IEC 63138-2

Edition 2.0 2023-10  
REDLINE VERSION

**Multi-channel radio-frequency connectors –  
Part 2: Sectional specification for MQ4 series circular connectors**

**Figure 1 – MQ4 socket connector**

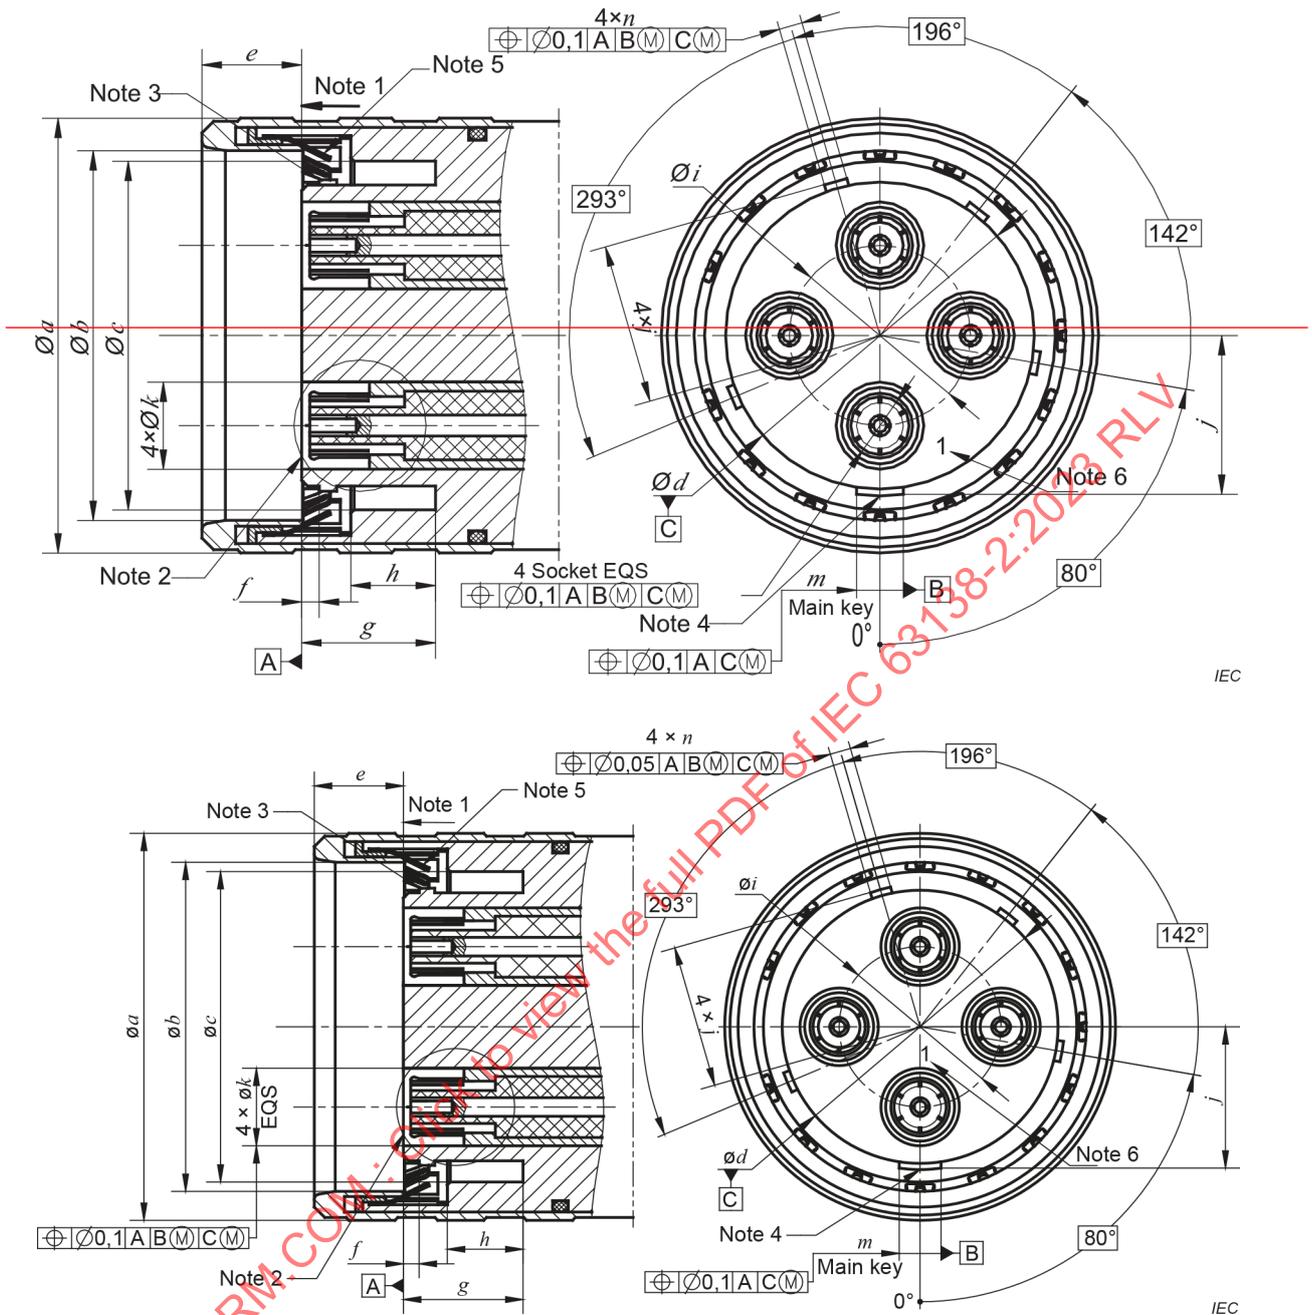
- a) change the supplementary key and groove position degree from 0,1 to 0,05 in Figure 1, Figure 2, Figure 3, Figure 7 and Figure 8;
- b) change dimension  $q$  from min.1,60 to min.1,65 in Table 1;
- c) add an electrical reference plane in Figure 4;
- d) add dimensions in Table 1;
- e) change dimension  $n$  from max.1,55 to max.1,50 in Table 2, Table 3 and Table 7;
- f) update some dimensions in Figure 4 and Table 4;
- g) change dimension  $a$  from min.7,50 to min.7,52, and max.7,60 to max. 7,58 in Table 7;
- h) update some dimensions in Figure 8 and Table 8;
- i) change mechanical compatibility from 50 N to 60 N in 4.2.3 and 4.2.4.

Figure 4 – Mating face of RF channel

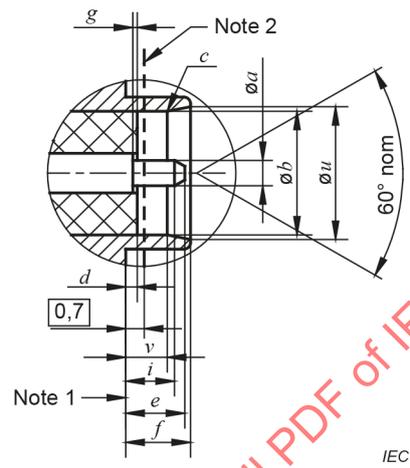
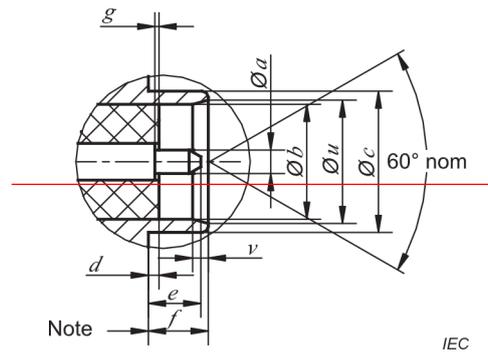
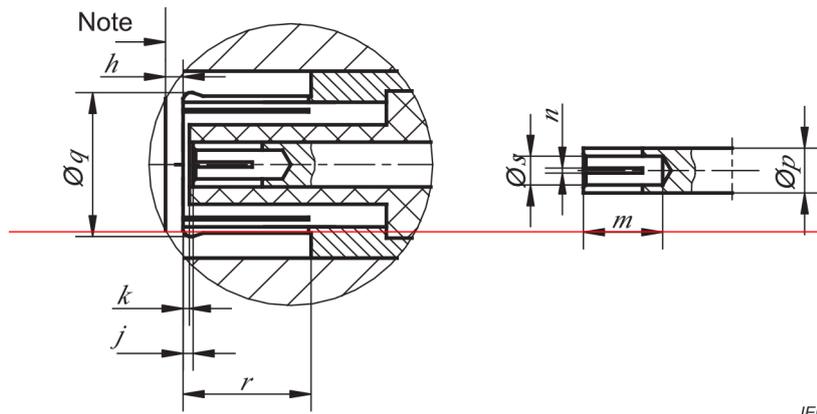
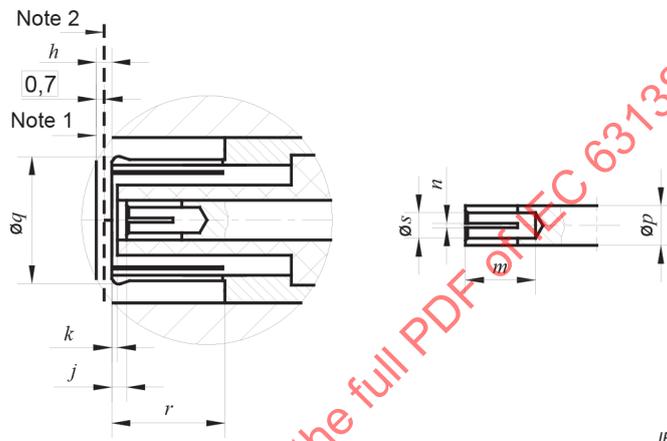
NOTE 2 Electrical reference plane.

- d) add dimensions in Table 1;
- e) change dimension  $n$  from max.1,55 to max.1,50 in Table 2, Table 3 and Table 7;
- f) update some dimensions in Figure 4 and Table 4;
- g) change dimension  $a$  from min.7,50 to min.7,52, and max.7,60 to max. 7,58 in Table 7;
- h) update some dimensions in Figure 8 and Table 8;
- i) change mechanical compatibility from 50 N to 60 N in 4.2.3 and 4.2.4.

**Figure 7 – Gauge for MQ4 socket connector**

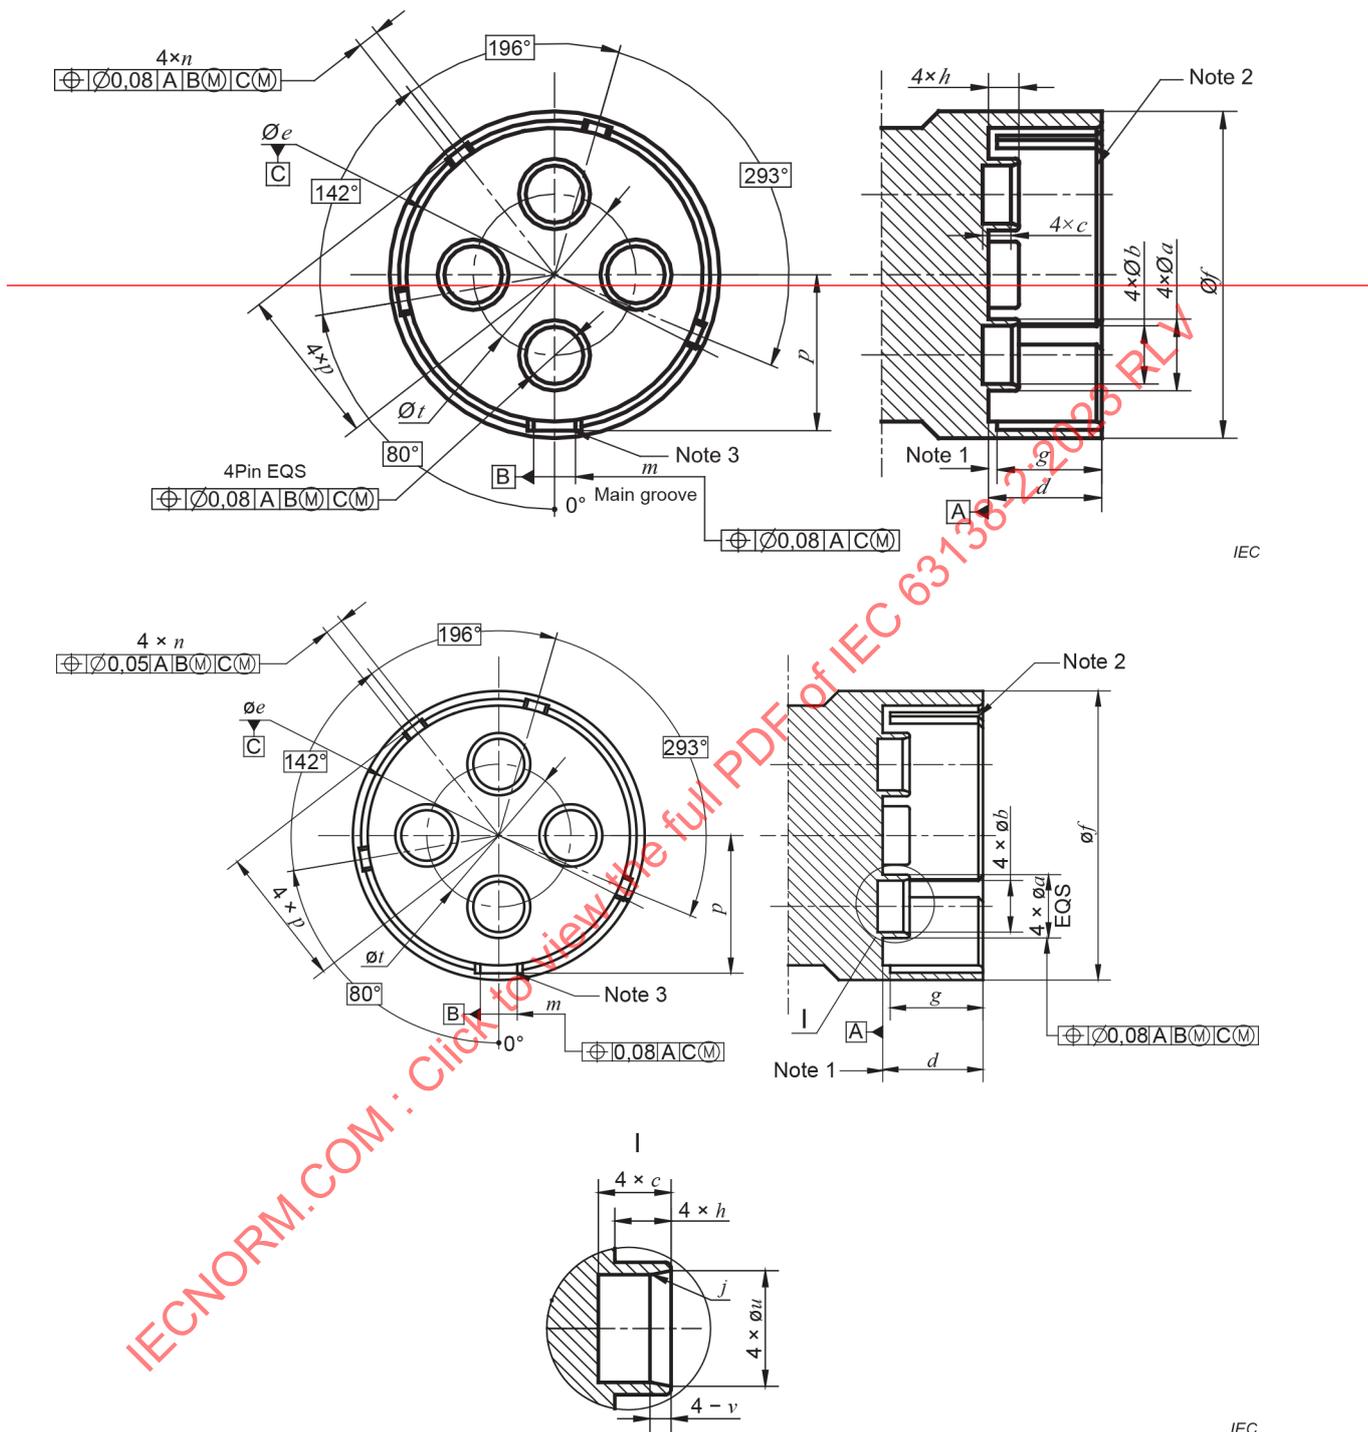
Ref.	Dimensions	
	mm	
	Min.	Max.
<i>a</i>	<del>7,50</del> 7,52	<del>7,60</del> 7,58
<i>b</i>	5,00	--
<i>c</i>	1,20	1,50
<i>d</i>	15,48	15,52
<i>e</i>	26,35	26,40
<i>f</i>	13,70	<del>13,85</del> 13,80
<i>m</i>	3,00	3,15
<i>n</i>	1,40	<del>1,55</del> 1,50

The gauge should be inserted into the MQ4 socket connector three times, and then the insertion force is measured; the insertion force should not be more than ~~50~~ 60 N.
